# FACPAC Contract Change Order

Tier 1 Project: CHHS Phase 2

**CHANGE ORDER NUMBER:** 6-5  
**INITIATION DATE:** 12/12/2025

**AIA**<sup>®</sup>**Document G709<sup>™</sup> – 2018****Proposal Request**

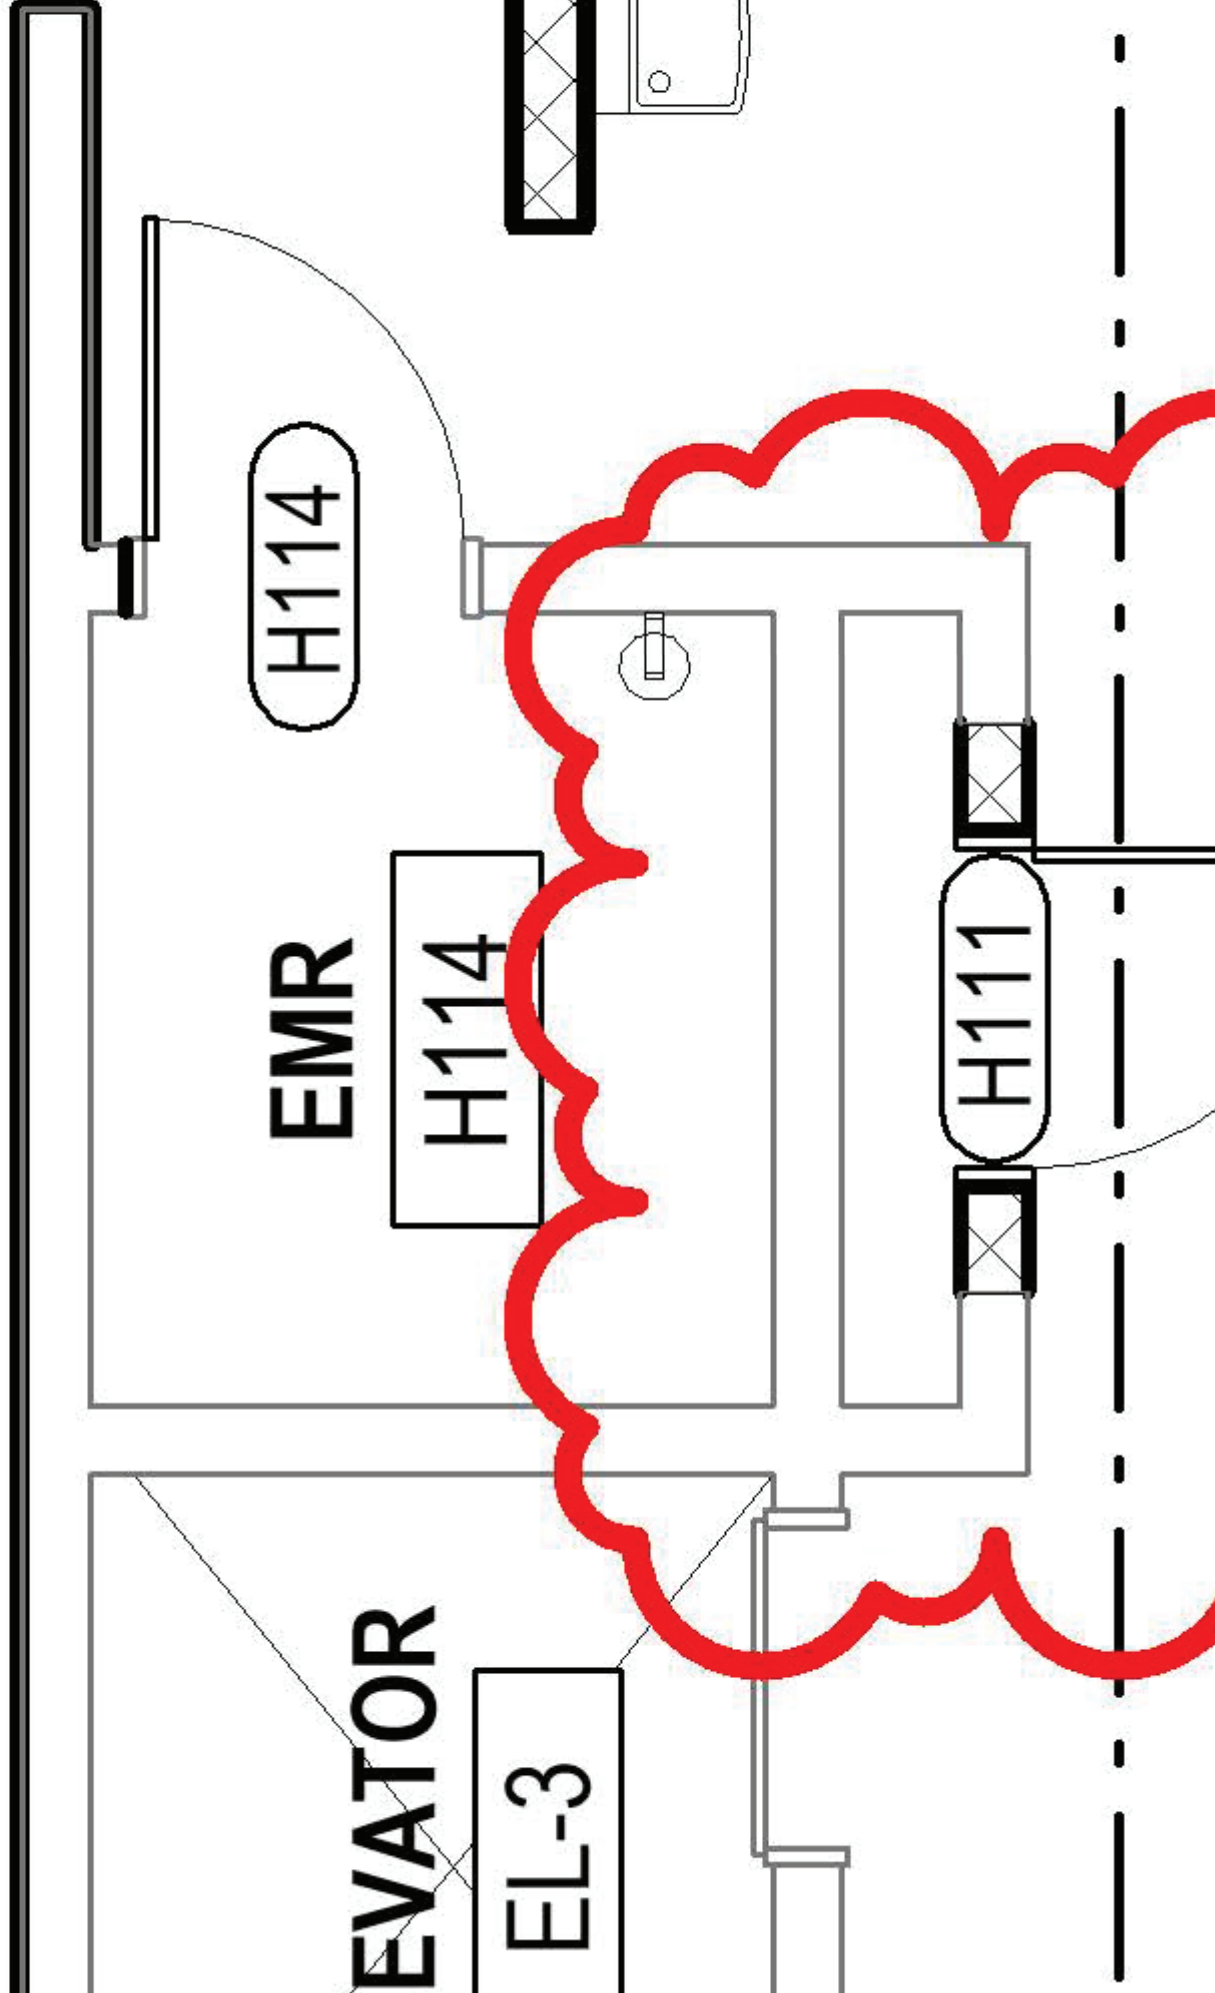
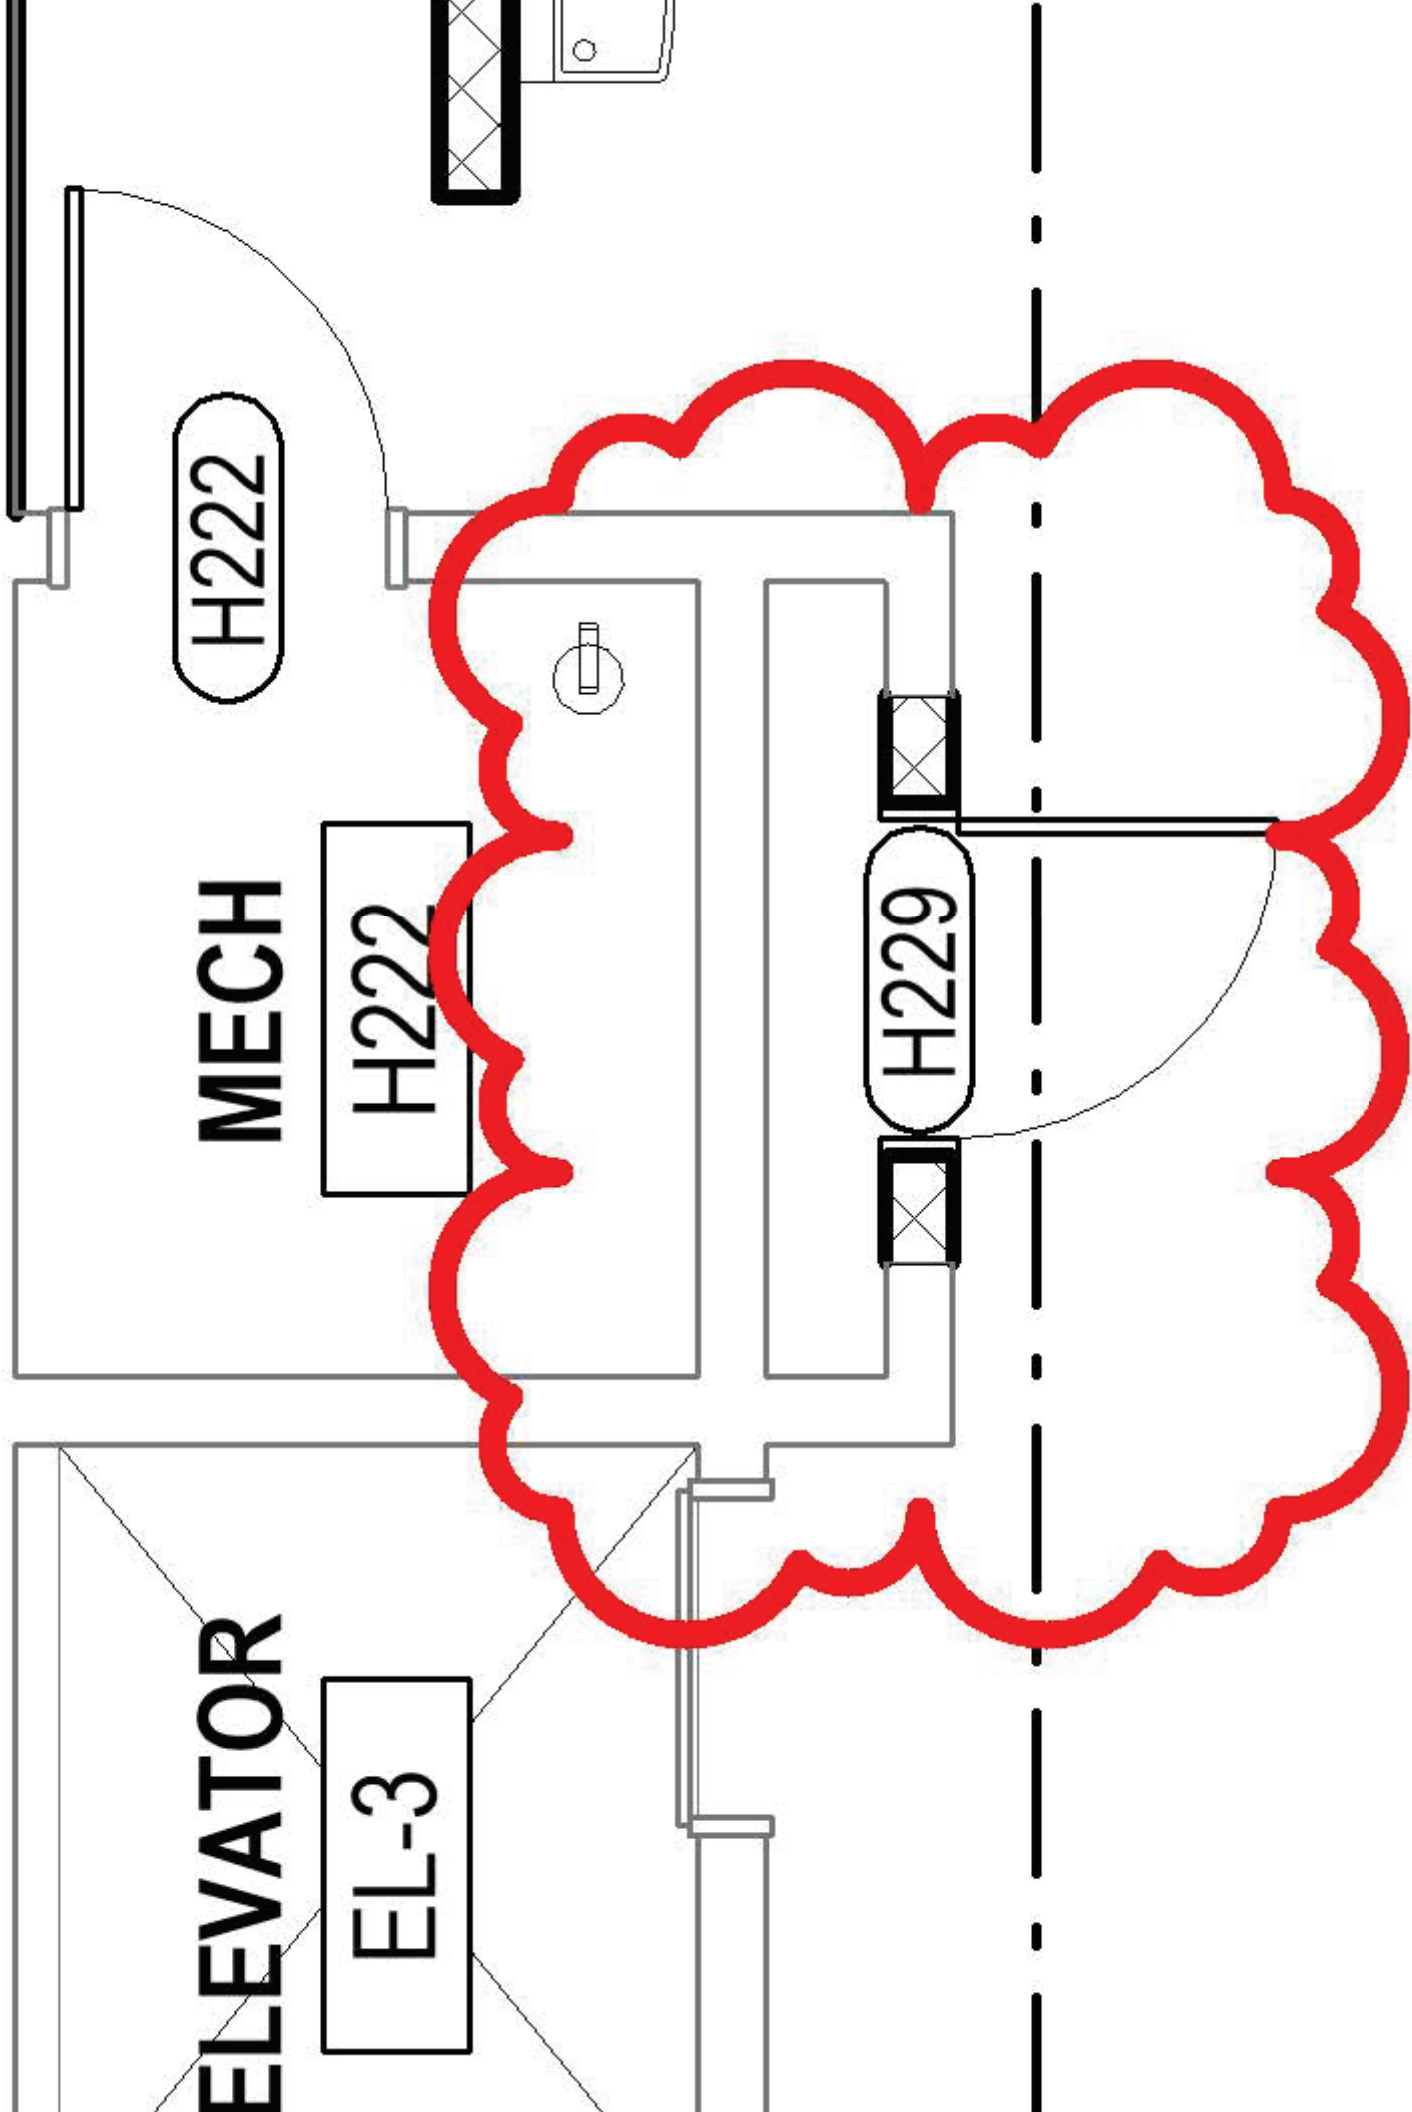
The owner would like to remove 2 display cases and turn them into closets.

Provide pricing for demolition of the sliding window, CMU below and bottom of display case. Provide a 3'-0" by 7'-2" single "Type F" wood door with hollow metal frame.

Match door hardware on H215A door. Infill with CMU as required.

Match adjacent finishes and paint interior of room P-1, add B-1 rubber base, RT-1 rubber flooring and add light fixture.
